Addendum No. 03

SUBJECT: Willamette River: Stormwater Source Control Improvements Project
Lower Columbia River, Northeast Portland, Stadium Freeway
Multnomah
Grading, Drainage, Paving, Signing, Illumination, and Roadside Development
(Bids Closing April 30, 2026)

1. Plan sheets BA03, BA04, BA08, C201, C581, ES01, FA201, FB201, GA201, HA201, HA401A, HB202, PA201, S02, TA201 are replaced with revised plan sheets BA03, BA04, BA08, C201, C581, ES01, FA201, FB201, GA201, HA201, HA401A, HB202, PA201, S02, TA201.

SHEET NO.
S02

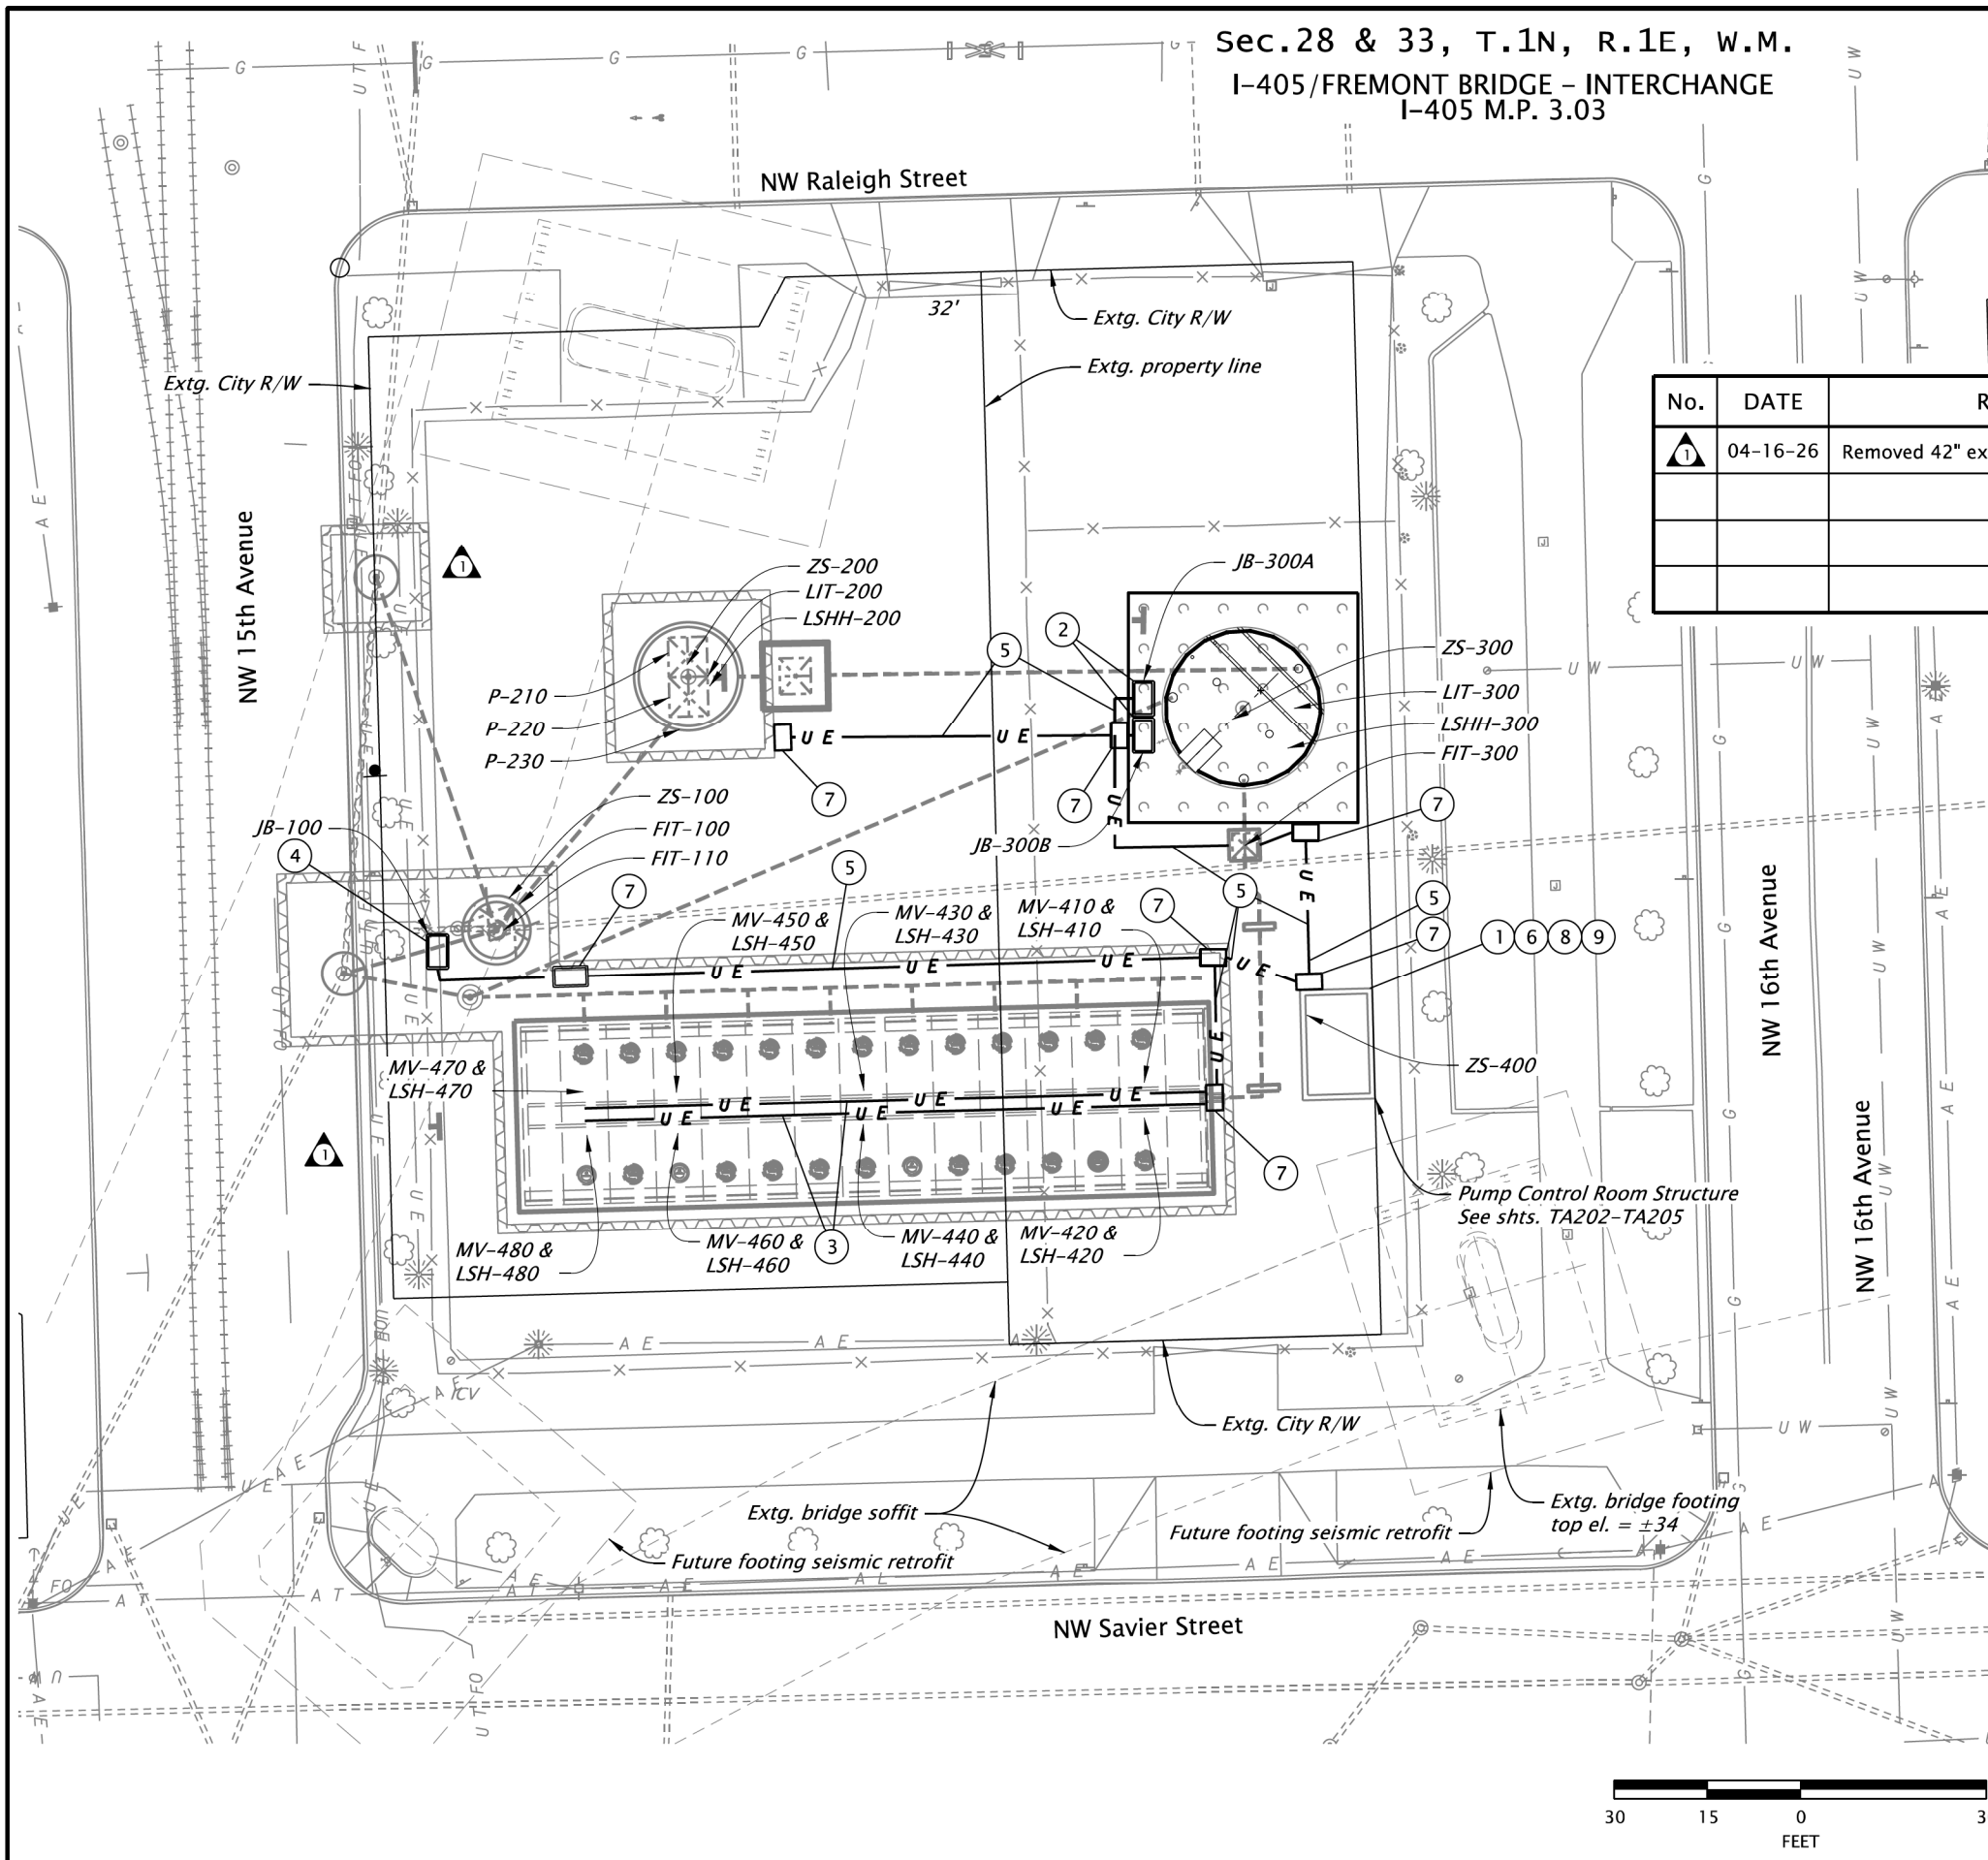
No.	DATE	REVISIONS	BY
1	04-17-26	Codes and standards note 1 – added year	A.P.J.
1	04-17-26	Structural concrete note 2 – added clarifying language	A.P.J.

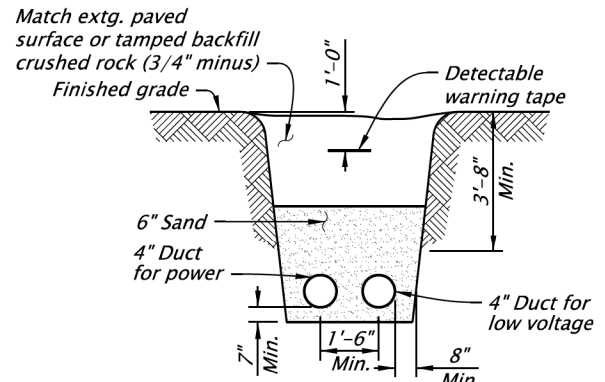
No.	DATE	REVISIONS	BY
1	04-16-26	Removed 42" extg. storm sewer pipe	J.G.H.
